May 2019
FL788A-O
NHTSA #18V-582
Transport Canada #2018-468
REVISED NOTICE

Subject: FCCC Motorhome Chassis Rear PDMs

Models Affected: Specific Freightliner Custom Chassis X-Line chassis manufactured November 23, 2015, through June 29, 2018, and equipped with a certain PDM.

Fig. 2, PDM Components

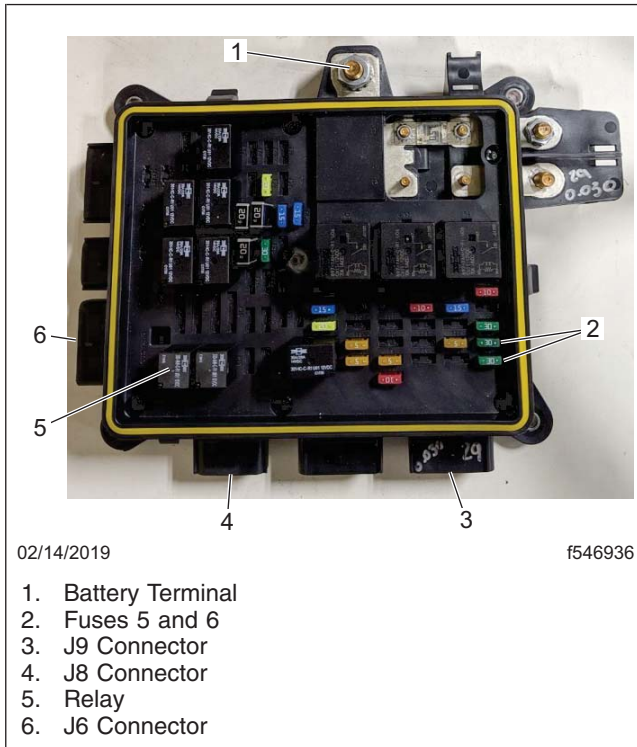
REVISIONS: The NHTSA number has been corrected to 18V-582, and the work instructions have been updated. On step 8 of the work instructions the probe locations have been corrected from F6 & F7 to F5 & F6 as well as fig. 2 has been updated to match the correct locations.

REVISIONS: The NHTSA number has been corrected to 18V-582, and the work instructions have been updated. On step 8 of the work instructions the probe locations have been corrected from F6 & F7 to F5 & F6 as well as fig. 2 has been updated to match the correct locations.

7. Connect the tester to the PDM. This includes three J-connectors and the test probe, along with the power and ground terminals. See [Fig. 3](#). Not shown in [Fig. 3](#) is the ground terminal connected to the negative terminal on the battery.
8. With the test probe plugged into the F5 and F6 locations of the PDM, ensure that the tester rocker switch is on the J6 location. See [Fig. 4](#), ref. A and item 1.
9. Move the momentary toggle switch on the tester to the ON-PIN6 location. See [Fig. 4](#), ref. B and item 2. This will read the voltage drop on the J6 connector in the Pin 6 location.
